IMPORTANT SAFETY RECALL

NHTSA Recall No. 24V-740

SN732

SUBJECT: Jib Extension Cylinder Rod Weld

Figure 1. Load Line Hook Secured to Anchor on Main Jib Boom

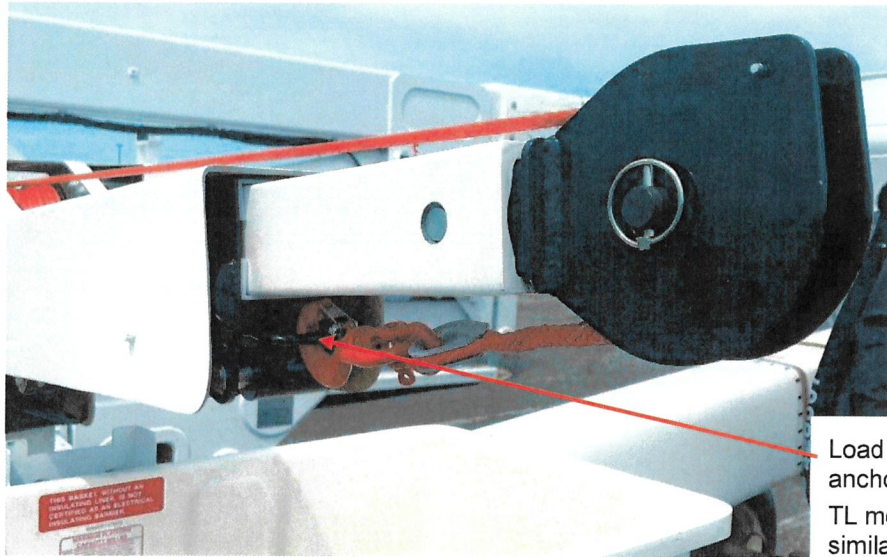
1. Always follow the inspection and maintenance requirements as specified in the manuals.
2. Ensure the jib extend hydraulic cylinder is at or above horizontal when loaded.
3. Secure the load line hook when stowing the machine as shown in Figure 1 below.

Figure 2. Included – Certain Top Mount Jib Assemblies

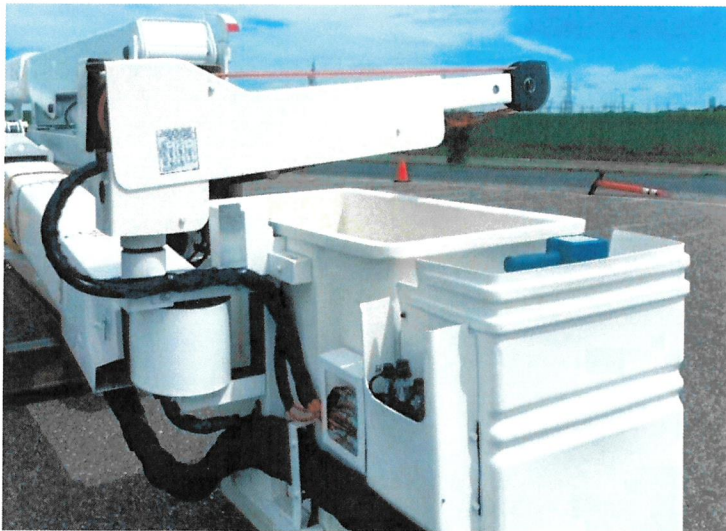
1. Deploy the outriggers and position the booms in the ground mount position clear of any obstacles. For the TM, position with the lower boom fully articulated and the upper boom articulated and extended so the basket is near the ground. For the TL80, TL80/112, and TL100, position with the lower boom raised to approximately 20 degrees, upper boom fully lowered and extended.
2. Visually inspect the jib assembly to determine if the jib assembly is affected using the Figures below as reference. Included are certain top mounted jibs, Figure 2.

Figure 3. Excluded – Dual Basket with Side Mount Jib Assembly

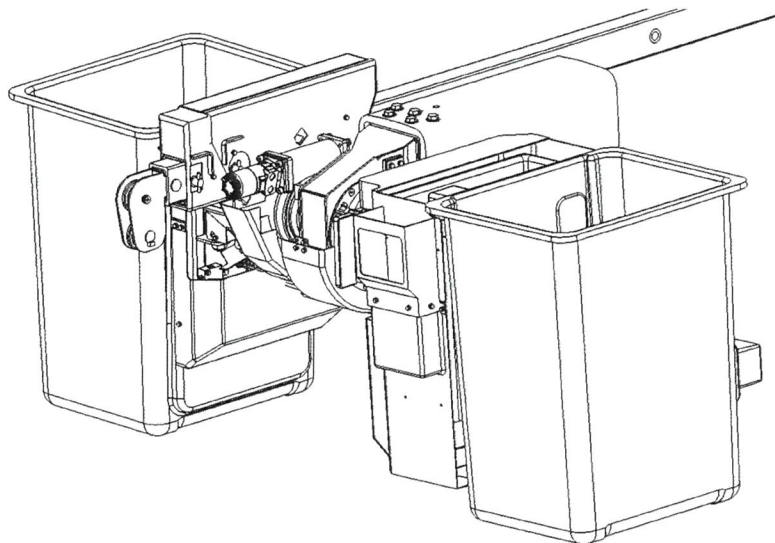
Excluded are dual basket machines where the jib is between the baskets, Figure 3, and single 2-man baskets with side mount jibs, Figure 4.

Figure 5. Location of Jib Extension Cylinder

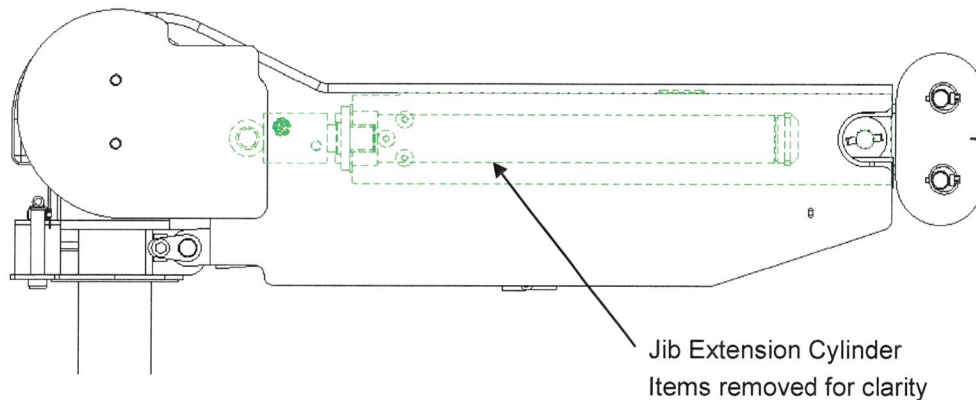
3. Locate the jib extension hydraulic cylinder, using Figure 5 below as reference.

Figure 6. Example Hydraulic Cylinder Date Code

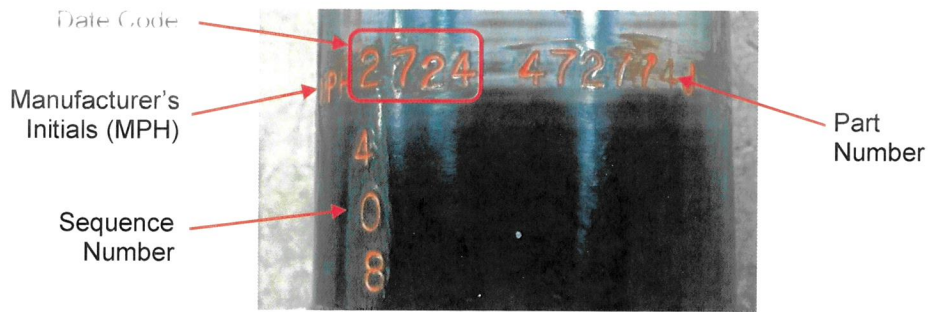
4. Remove covers as needed and remove the jib extend hydraulic cylinder following the instructions in the Maintenance Manual of your machine.
5. Using Figure 6, inspect the part number and date code on the hydraulic cylinder. The first two numbers in the date code are the week the cylinder was manufactured. The second two numbers are the year the cylinder was manufactured. The example below was manufactured week 27 in 2024. Sequence number 408 represents this was the 408th cylinder manufactured in week 27 in 2024.

6. Any MPH hydraulic cylinder with part number 472774 and date codes and sequence numbers shown in the table below stamped in the case is subject to the recall and will need the hydraulic cylinder replaced.

7. Any MPH hydraulic cylinder with part number 472774 stamped in the case that does not fall in the above date code and sequence number combination is not subject to the recall and can continue to be used.
